Access Compliance Report

Public Rights-of-Way

(Curb Ramps)

Intersection ID: 19934	Main Street: W_ARROWWOOD_RD	Cross Street: WHITEHALL_EXECUTIVE_CENTER_DR	Location: NE
ADA ID: B9CA560D490A	Ramp Type: Perp	Initial Pass/Fail: Fail	Overall Compliance: No
Severity Score: 21.25			
Codes/Mitigation Info/Possible Solution		Field Measurements/Component Compliance

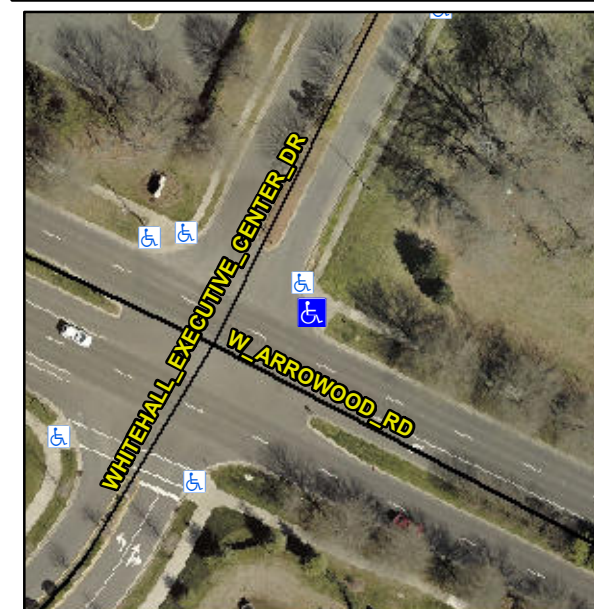
Not Found, R304.5.1, R304.5.3

Compliance	Description	Data	Compliance	Description	Data
N/A	Ramp Length (in)	151.0	Yes	Ramp Slope (%)	6.6
No	Ramp Width (in)	44.0	No	Ramp XSlope (%)	6.5
N/A	Flare Type LT	N/A	N/A	Flare Type RT	N/A
N/A	Flare Slope LT (%)	N/A	N/A	Flare Slope RT (%)	N/A
N/A	Flare Traversable LT?	N/A	N/A	Flare Traversable RT?	N/A
N/A	Landing Length (in)	N/A	N/A	DWS Provided?	N/A
N/A	Landing Width (in)	N/A	N/A	DWS Contrast?	N/A
N/A	Landing Slope (%)	N/A	N/A	DWS Length (in)	N/A
N/A	Landing X Slope (%)	N/A	N/A	DWS Full Width?	N/A
N/A	Landing Curb? (Y/N)	N/A	N/A	DWS Offset (in)	N/A
N/A	Shared Landing?	N/A			
N/A	Gutter Ponding?	N/A	N/A	Gutter Slope (%)	N/A
N/A	Gutter Lip Ht (in)	N/A	N/A	Gutter X Slope (%)	N/A
N/A	Painted X Walk1?	No	N/A	Painted X Walk2?	N/A
	X Walk 1 Direction	To SW		X Walk 2 Direction	N/A
N/A	X Walk 1 Width (in)	N/A	N/A	X Walk 2 Width (in)	N/A
	X Walk 1 Slope (%)	2.1		X Walk 2 Slope (%)	N/A
	X Walk 1 X Slope (%)	0.7		X Walk 2 X Slope (%)	N/A

Remove & Replace Entire Ramp.
